PLANNING, ZONING, & BUILDING DEPARTMENT
PZ&B Staff Combination Memorandum: Architectural Commission and Town Council

SUBJECT: ARC-24-0015 (ZON-24-0008) 253 SEMINOLE AVE (COMBO)

MEETING: AUGUST 28, 2024 ARCOM
SEPTEMBER 11, 2024 TC

Area of Work

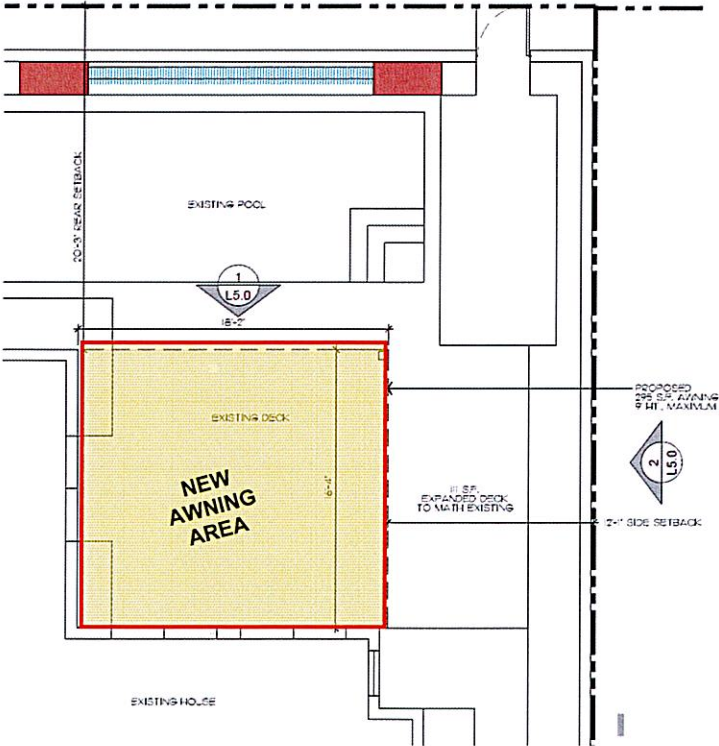
The applicant is proposing the construction of a new canopy awning structure at the rear of the property at the pool deck. A preliminary review of the project indicates that the application, as proposed, is inconsistent with the Town zoning code and requires one (1) variances to achieve the application as proposed.

The subject property is one-half of a duplex located on the north side of Seminole Avenue. The proposed awning addition is 295 SF and is proposed over existing decking and planter areas at the rear of the structure. The height of the awning will not exceed 9' in height. The applicant proposed to expand existing nonconforming hardscape to the east by removing sod and installing 111 SF of acid washed white cast stone to match existing deck materials, however, ARCOM did not approve the hardscape expansion in the scope. No other landscape changes are proposed. The site is nonconforming to both lot coverage and landscape open space regulations as it exists. The proposed changes exacerbate the nonconformities and require variances from the zoning code.
